APPLICATION FOR DISPOSAL SYSTEM CONSTRUCTION PERMIT

Title INDIVIDUAL SEWAGE DISPOSAL SYSTEM FOR A PROPOSED 5-BEDROOM HOUSE...

5-BEDROOM HOUSE
LOT 14 MURPHY PLAN
15 PINE LANE
WEST TISBURY, MASS.

(A.P. 10-268)

DATE: 7-10-17 DESIGNED BY: D.O.D. CHECKED BY: D.O.D. SHEET 1/1

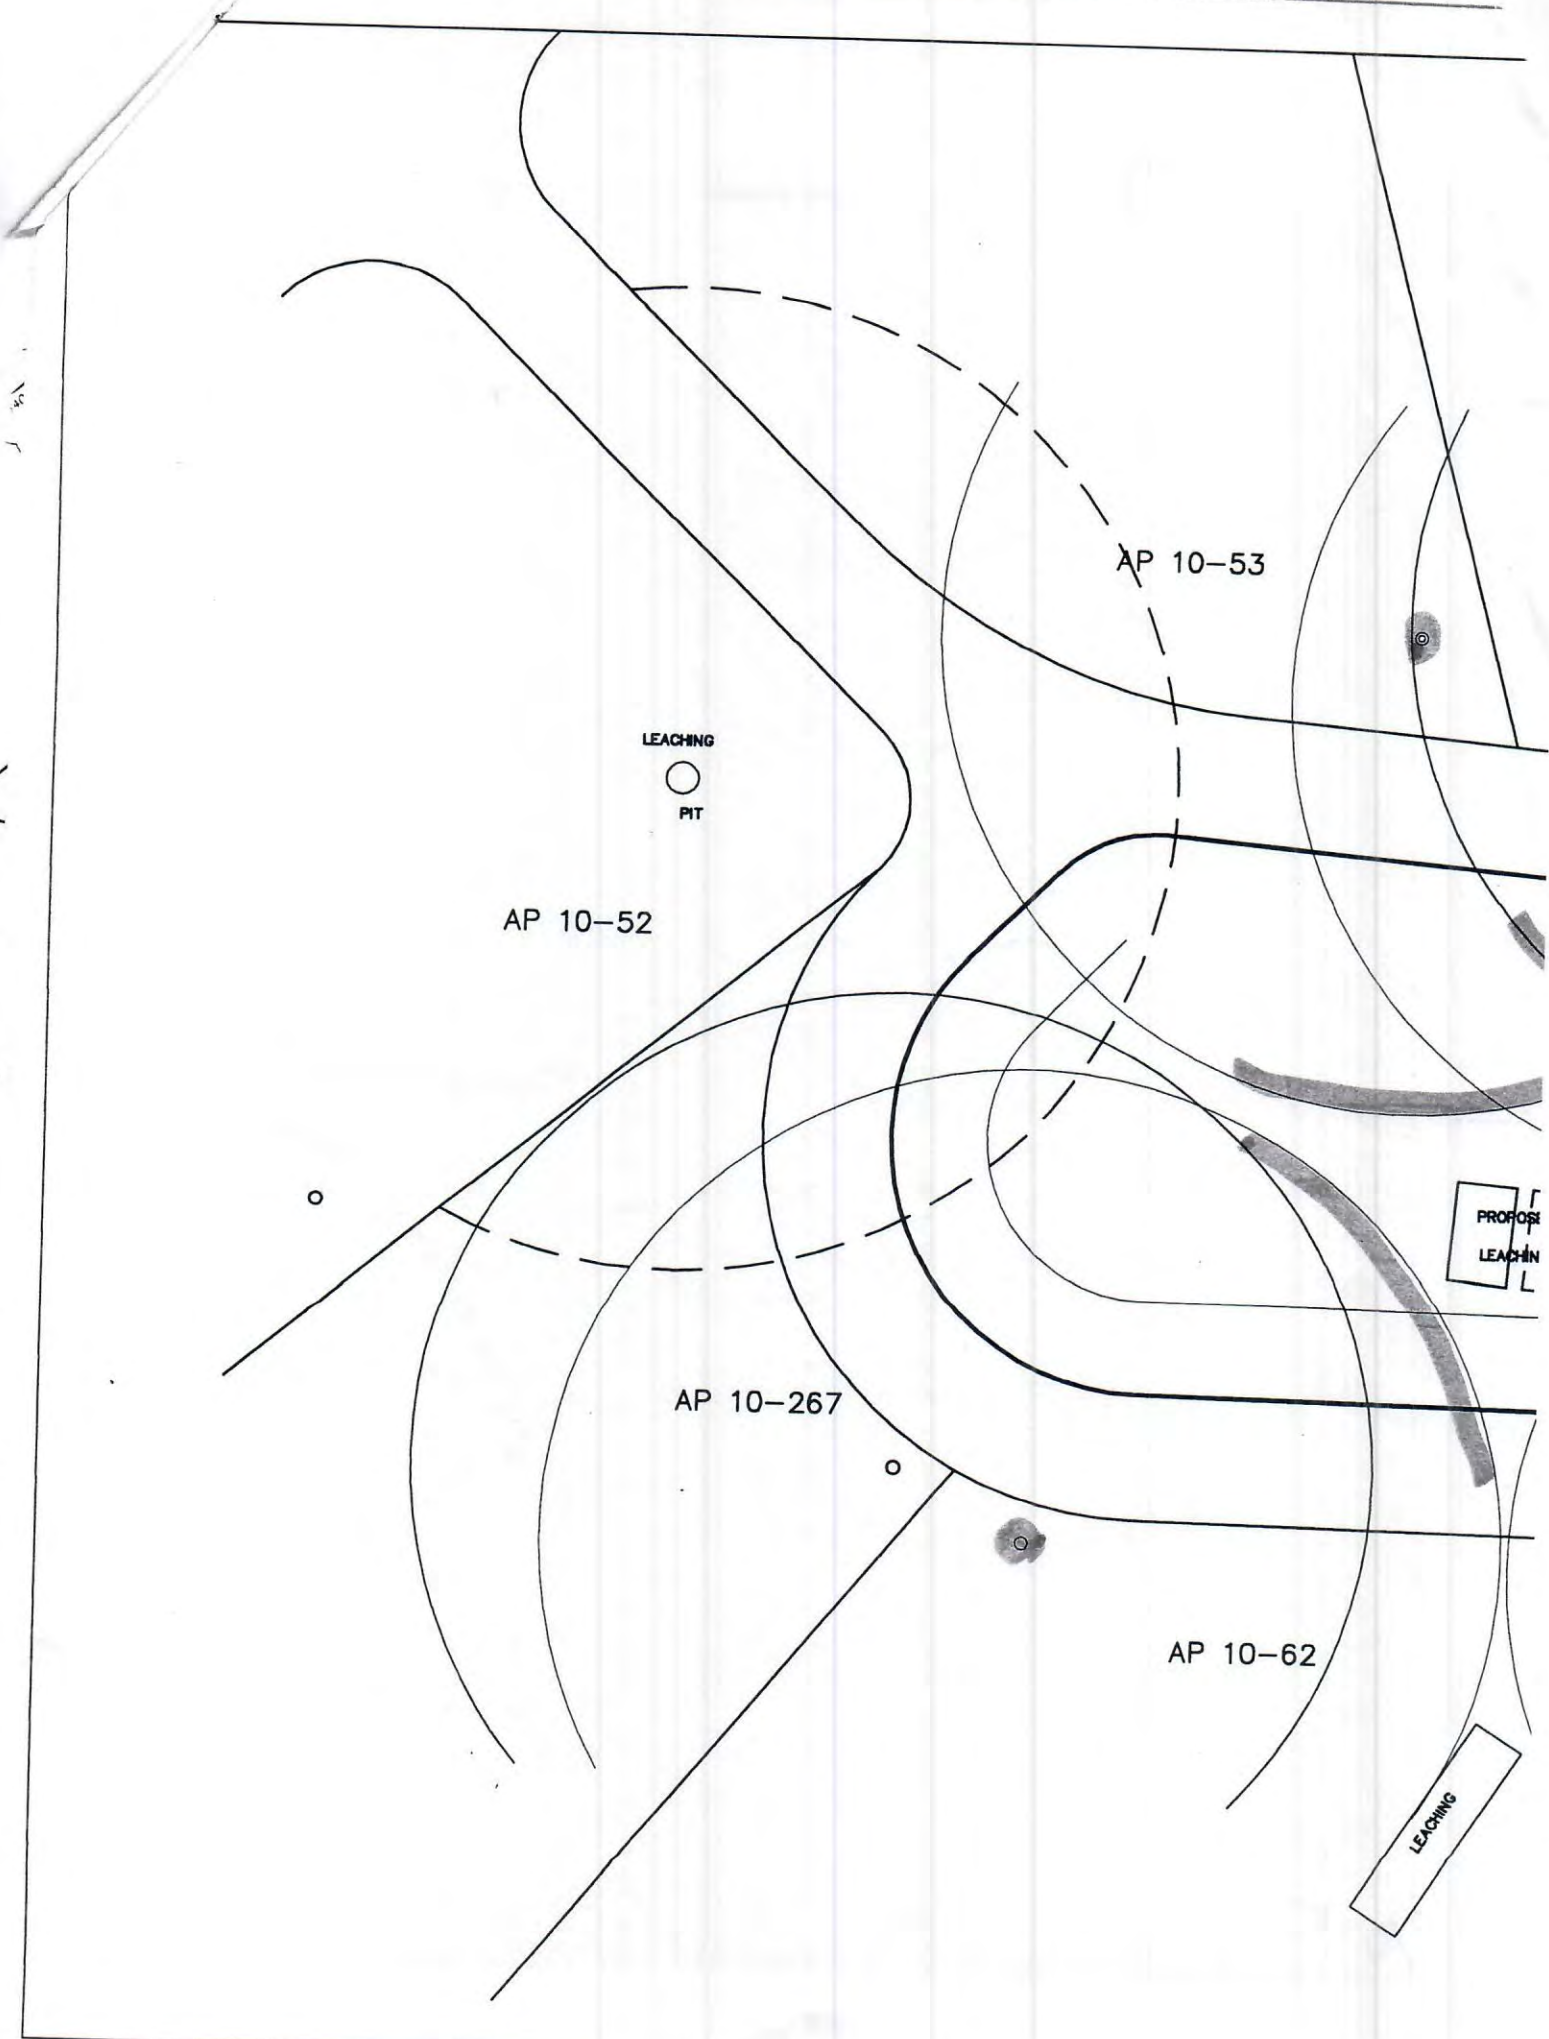
- ~~6. All washed stone in the leaching field must be double washed in accordance with 310CMR 15.247.~~
7. Tight joint piping to consist of Polyvinyl Chloride pipe (PVC), Schedule 40 unless otherwise noted. All joints between concrete and piping to be *Plan Review Only*

8. Finished grading to be done in accordance with *5 BR. proposed* and Schedule of Elevations.
9. Heavy machinery shall not be permitted *will need well info* during or after construction.

10. No permanent structure may be *will need well info*
11. SMITH & DOWLING will not be responsible for the performance of this system, unless constructed as shown. Any alterations must be approved in writing by design engineer.

Plan OK
